NORTH BAY AT LAKE WOODMOOR
CONSTRUCTION DOCUMENTS

PCD FILE NO.: SF263

CONSTRUCTION DOCUMENTS
SITE PLAN & HORIZONTAL CONTROL PLAN

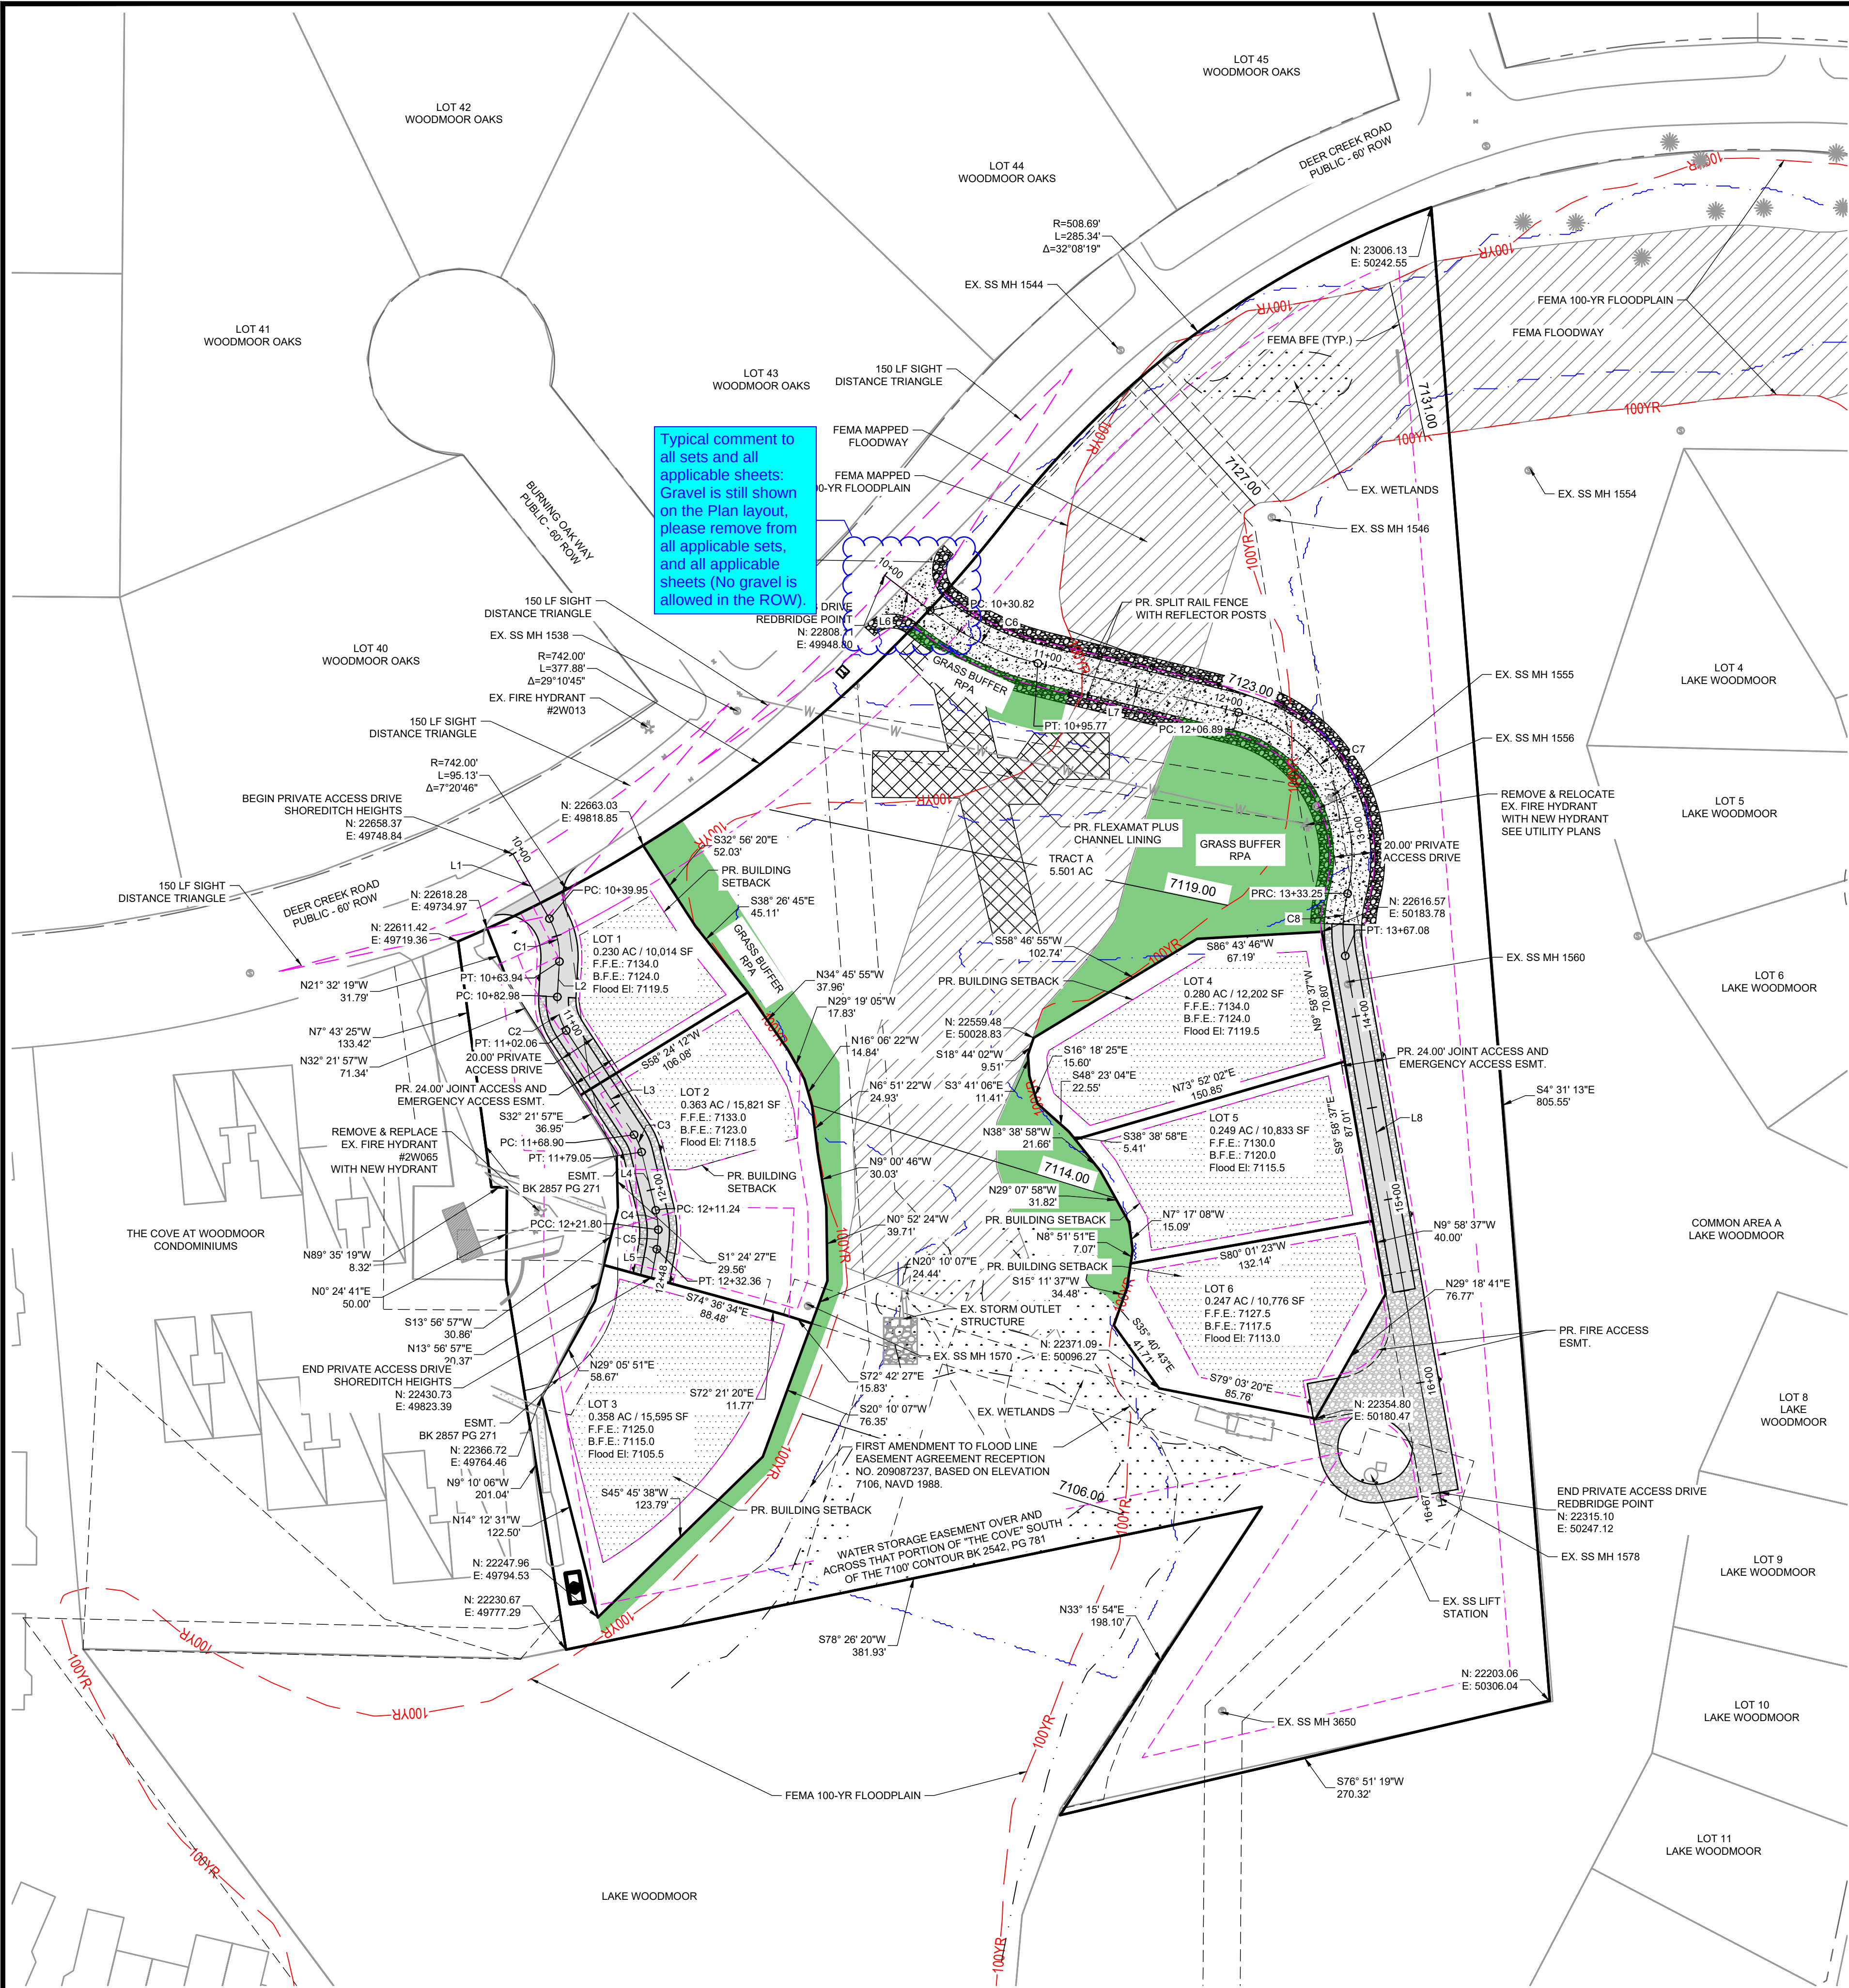
See comment about gravel on the Utility Construction Drawings.
